FCC Class II Permissive Change Request Letter

RE: FCC Permissive II Change Request for Company: Arovast Corporation FCC ID: 2ARBY-CS168

Power board change description

三、Comparison before and after the Power board change

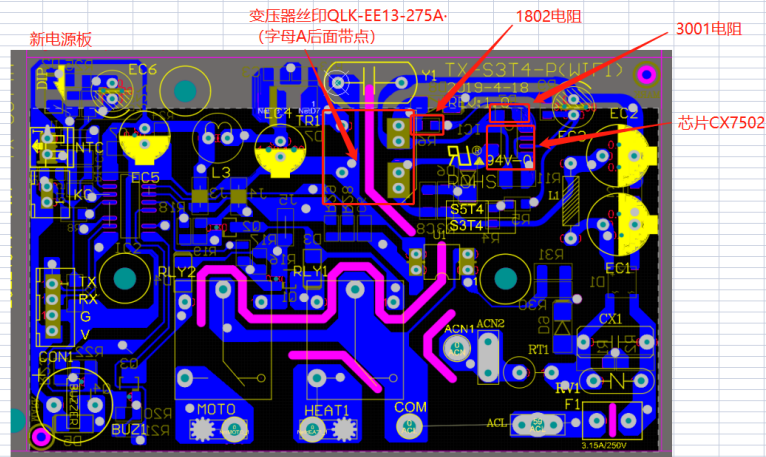
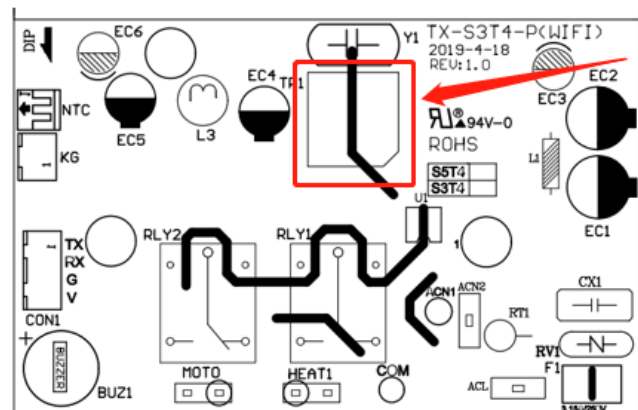
- 1、The R6 resistor is changed to “1060144-R-0805-K-1802-F-T”
- 2、The R7 resistor is changed to “1060214-R-0805-K-3001-F-T”
- 3、IC1 chip changed to “3052330-CX7502 (SOP-7) ”

三、 Comparison before and after the Power board change

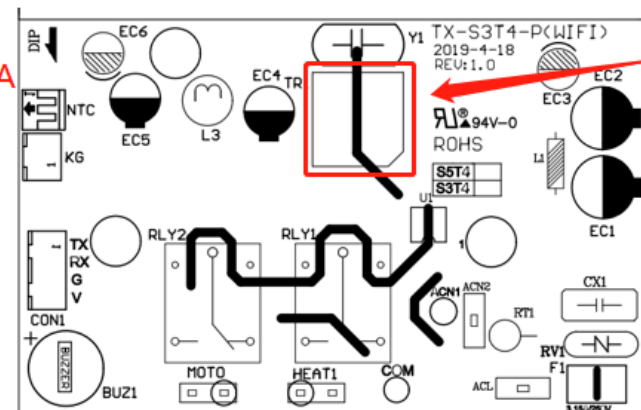
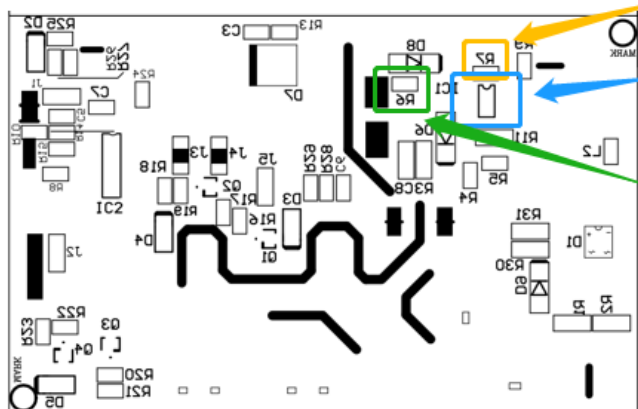
变压器丝印
QLK-EE13-257A

变压器丝印
QLK-EE13-2
57A· (字母A
后面带点)

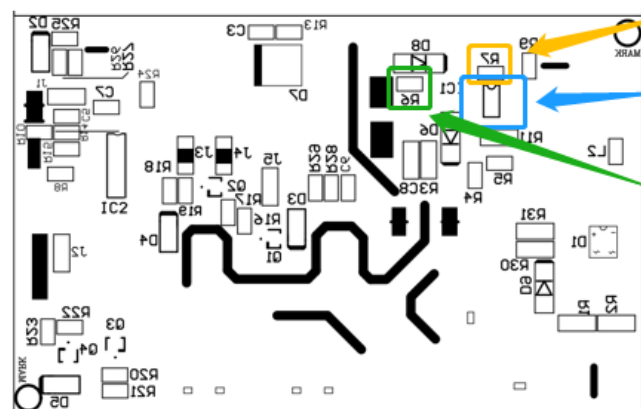
2701电阻

CX7501芯片

1912电阻

3001电阻

CX7502芯片

1802电阻
